RE: Petition No. 1337
Stepstone to Green Hill Upgrade Project
Amendment to Petition

ATTACHMENT A

EVERSOURCE ENERGY									
Stepstone to Green Hill Upgrade Project									
Guilford, CT									
Map Sheet 4 of 9									
March 1, 2018									
NO.	DATE	REVISIONS	BY	CHK	APP	APP	DAVISON ENVIRONMENTAL		
							ALL-POINTS TECHNOLOGY CORPORATION

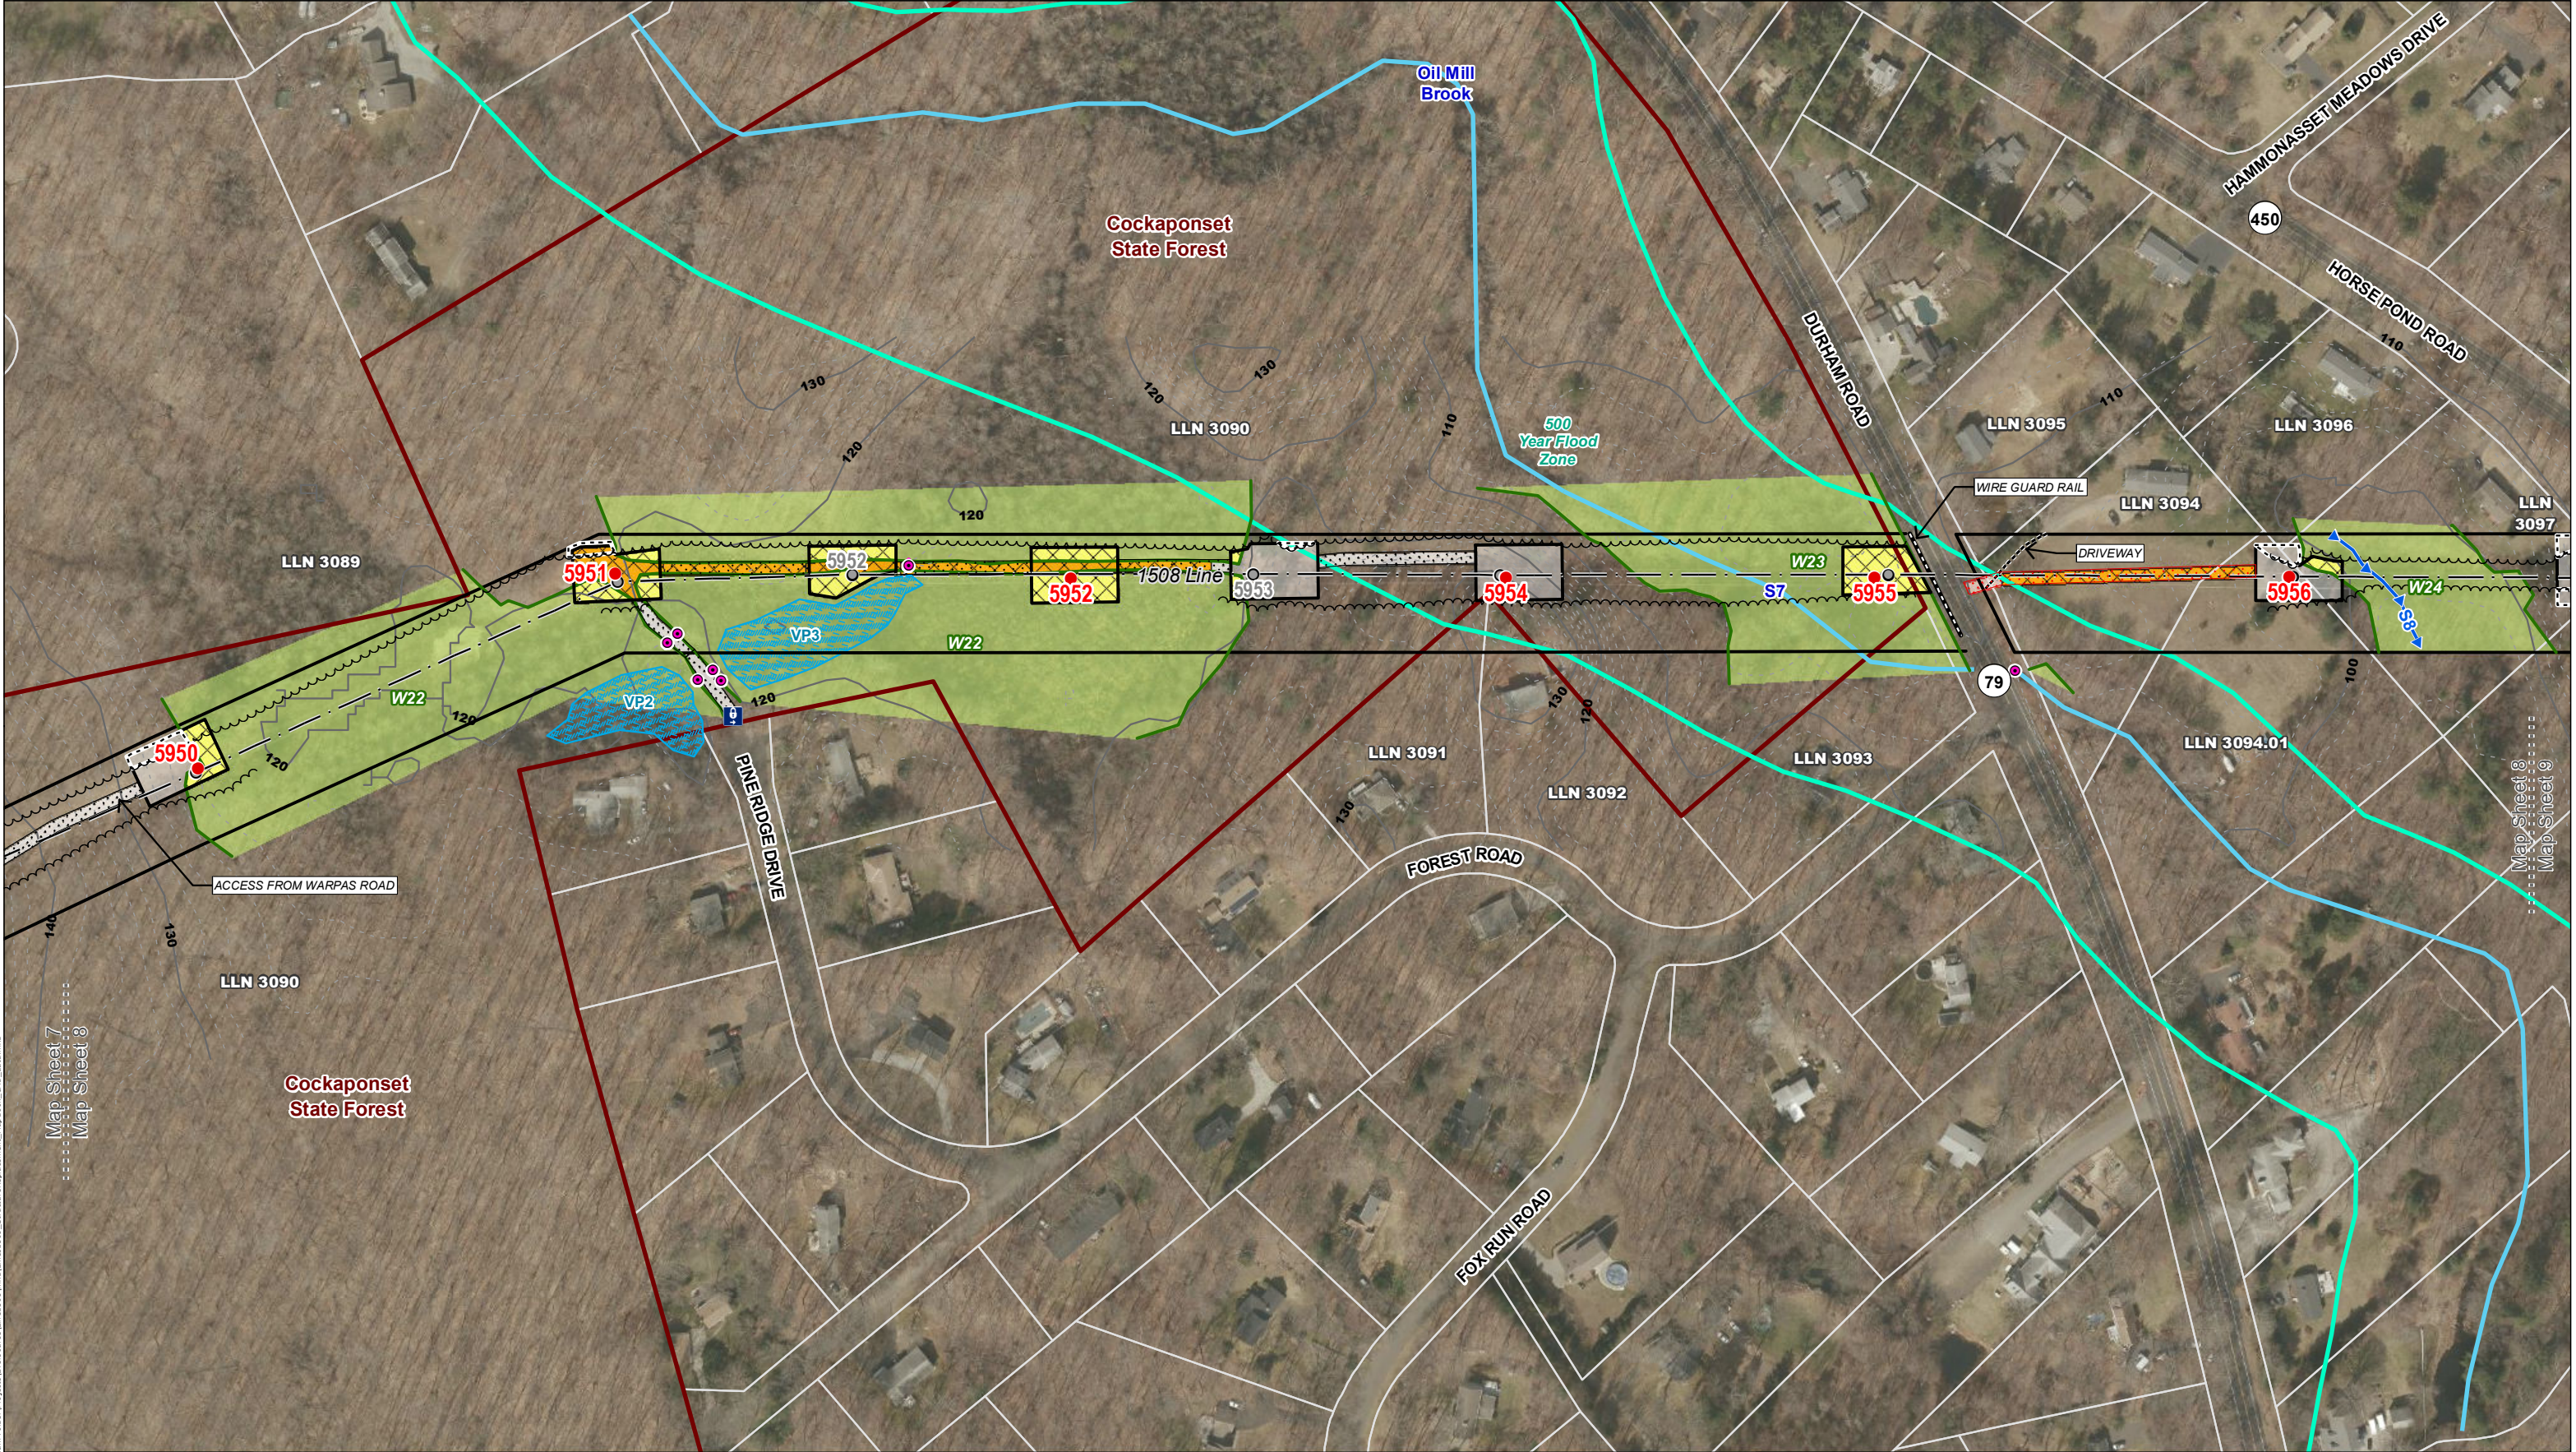
In its decision letter, the Council directed Eversource to, "consider the feasibility of shifting structure 5924 to the Southwest to the extent practicable, to avoid wetland disturbance". Subsequent to the Council's ruling, Eversource has re-evaluated the structure location and is proposing to relocate structure 5924 approximately 13 feet to the northwest from the originally proposed location to farther away from the wetland.

1. Change the existing construction work area at Structure 5915 from gravel area (20 feet x 70 feet) to a construction pad (60 feet x 70 feet) reduces the risk of impact to the wetland. The construction mat will not affect the wetland.
2. Relocate structure 5941 approximately 12 feet northwest from the previously proposed location on the same property in order to better accommodate the alignment of the conductor.
3. Relocate structure 5956 approximately 25 feet west from the previously proposed location in order to remain on the same property as the existing structure. The new location will locate the structure further away from the wetland.
